November 2, 2004

Palisades Nuclear Plant
Docket 50-255
License No. DPR-20

License Amendment Request: Additional Restrictions to Primary Coolant System
Cooldown Rate Limits

Figure 3.4.3-2 (Page 1 of 1)
Pressure – Temperature Limits for Cooldown

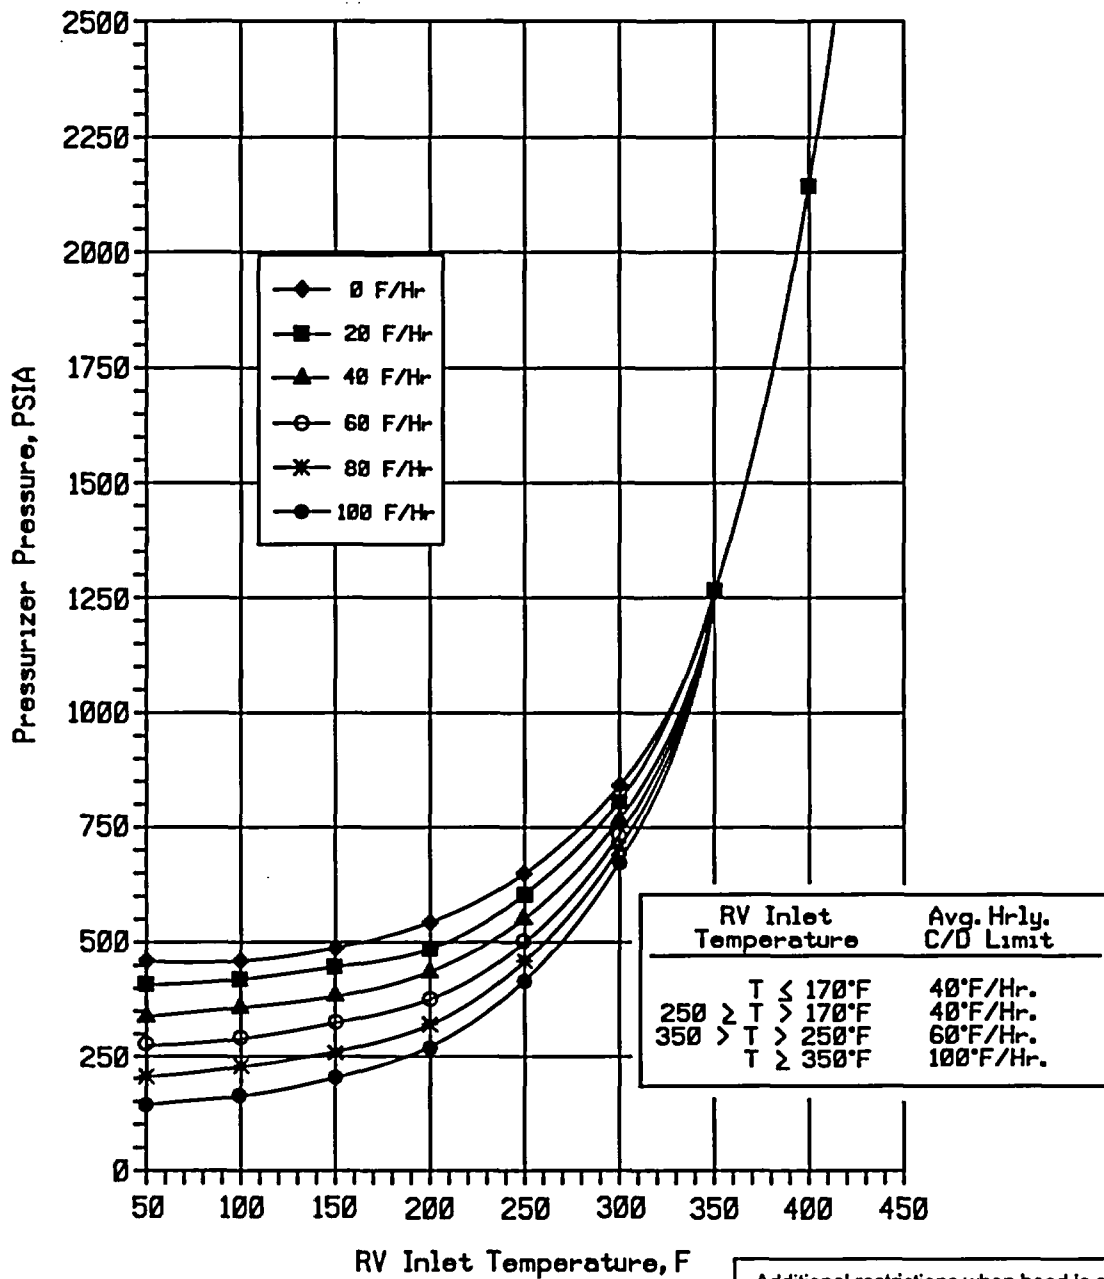
NMC proposes to revise TS LCO 3.4.3, Figure 3.4.3-2 (Page 1 of 1) with the following additional restrictions when the head is on the reactor vessel:

1. Maintain average core exit temperature:
 $135^{\circ}\text{F} \geq T \geq 110^{\circ}\text{F}$ for ≥ 3 hours.
2. Following completion of item 1, maintain average hourly cooldown (C/D) limit of $20^{\circ}\text{F}/\text{hour}$ based on core exit temperature indication.

Consequently, these analyses require additional restrictions during cooldown operations to ensure Code requirements are met. NMC proposes to add the restrictions to TS 3.4.3. By requiring a three-hour hold period between reactor

coolant temperatures of 110°F to 135°F, and an average cooldown rate that is limited to 20°F/hour thereafter, the repairs to CRD nozzles #29 and #30 will satisfy the 1989 Section XI Code criteria for a fracture toughness margin.

Additional restrictions when head is on reactor vessel:

1. Maintain average core exit temperature:
 $135^{\circ}\text{F} \geq T \geq 110^{\circ}\text{F}$ for ≥ 3 hours.
2. Following completion of Item 1, maintain average hourly cooldown (C/D) limit of 20°F/hour based on core exit temperature indication.

Figure 3.4.3-2 (Page 1 of 1)
Pressure – Temperature Limits for Cooldown

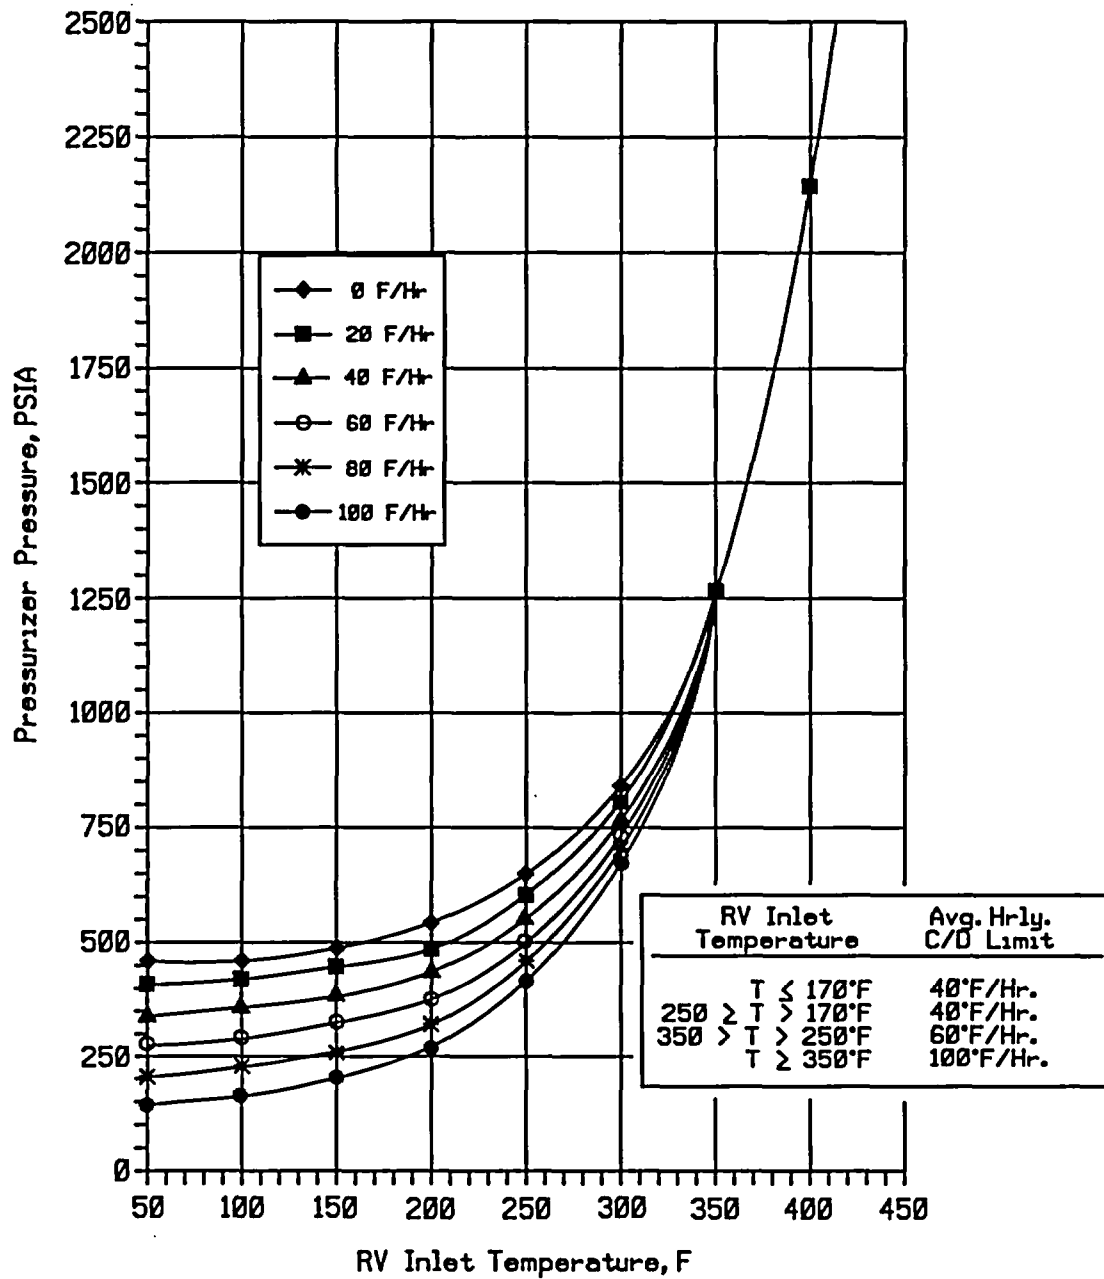
MARK-UP OF TECHNICAL SPECIFICATION PAGE

3.4.3-4

(showing proposed changes)

(additions are highlighted; deletions are strikethrough)

Additional restrictions when head is on reactor vessel:

1. Maintain average core exit temperature:
 $135^{\circ}\text{F} \geq T \geq 110^{\circ}\text{F}$ for ≥ 3 hours.
2. Following completion of item 1, maintain average hourly cooldown (C/D) limit of 20°F/hour based on core exit temperature indication.
